Hobsons Bay Heritage Referral

Date	7 July 2025
Property	Williamstown Surf Life Saving Club (WSLSC)
Application No.	PA250139
Proposal	Partial demolition, buildings and works associated with the re-development of the WSLSC
Heritage Status	Contributory to Esplanade Foreshore Heritage Precinct (HO5)
Planner	s 33

Fig 4: A comparison of the proposed existing roof form with the two western hips in red to be demolished (left) and the retained part with its smaller altered form on the right. The extent of demolished fabric of primary significance is very high.

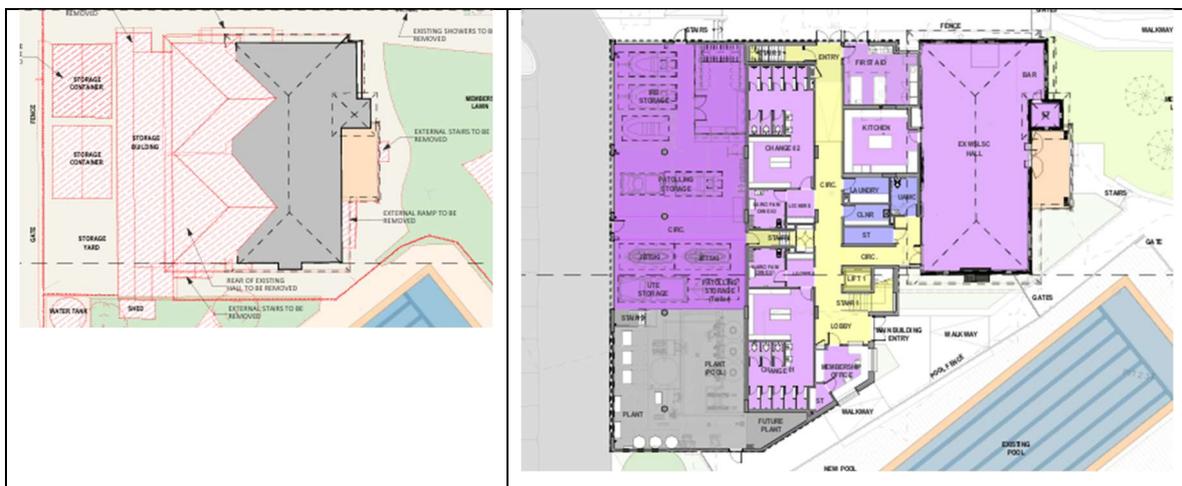
The partial demolition and change in form to the 1935 clubhouse is contrary to heritage policy and guidelines. It involves demolition of the western part of the clubhouse including removal of its two hipped roofs and interior service spaces. The whole of the 1935 building is of primary significance so this demolition involves the removal of fabric of primary significance.

It also distorts the historical record in that the clubhouse will appear as if it was always in this diminished form. The architectural design of the clubhouse will be altered and it will appear as a much smaller building instead of reflecting the historical importance of Williamstown Beach during the Interwar period in its scale and design.

Fig 5: Diagram of floor levels and ceiling heights. Source: HIS p48

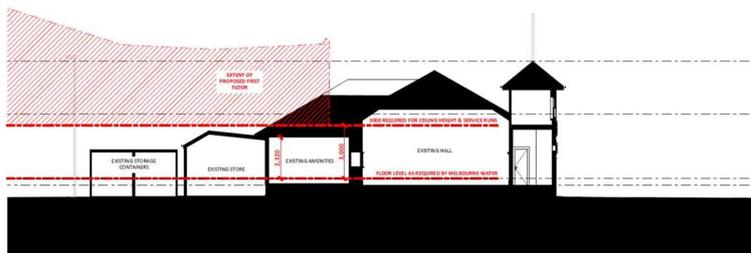
The HIS states that Melbourne Water advised that the floor level for the clubhouse be raised by 400mm and the consultant team chose not to apply this to the hall to protect the existing space. The HIS argues that it would be applied to the service areas and this rise, in conjunction with the comparatively lower ceiling height in this area, makes these rooms unusable. The diagram below shows that a height of 2320 would be achieved and the HIS states that a height of 3000 is needed.

There are no heritage controls on the interiors of the clubhouse. The service spaces have been altered and are not considered special. It may be possible to gain extra clearance if the existing

ceiling was removed and a higher ceiling installed, potentially partly raked like the hall. This would probably allow for the retention of the whole of the original external form, including the hipped roof forms to the west.

It is notable that the higher floor level suggested by Melbourne Water has not been applied to the new building. The new service areas which replace the demolished ones have the same finished floor level as the hall. It is unclear why a rise in floor level is necessary for the old service areas but not the new.

Fig 6: North elevation showing the proximity and scale of the addition to the retained heritage fabric.

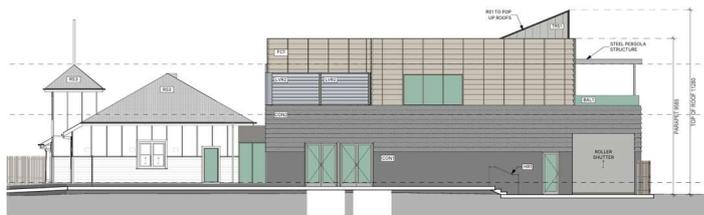
The height and mass of the proposed addition to the rear of the hall makes it visually dominant compared to the heritage building. It is a much larger floor area and extends well to the south of the clubhouse with a two storey form. The top of the roof of the clubhouse tower is just over 7 metres tall with the roof ridge and the hipped ends of the clubhouse well below this. Although the new structure is only two storeys, it has a parapet roof form at over 9.5 metres and sawtooth roofs at over 11 metres. The sawtooth roofs are clad in polycarbonate so will be lit up at night when lights are on inside.

The upper floor of the new addition is only separated from the heritage hall by a box gutter. The impact of the taller and wider mass will be substantial on the east elevation facing the beach. However an east elevation of the clubhouse with the addition has not been provided. Drawing TP 313 shows the addition without the heritage building and TP 311 is an elevation of the clubhouse with only part of the addition behind it. No sight line diagrams have been provided.
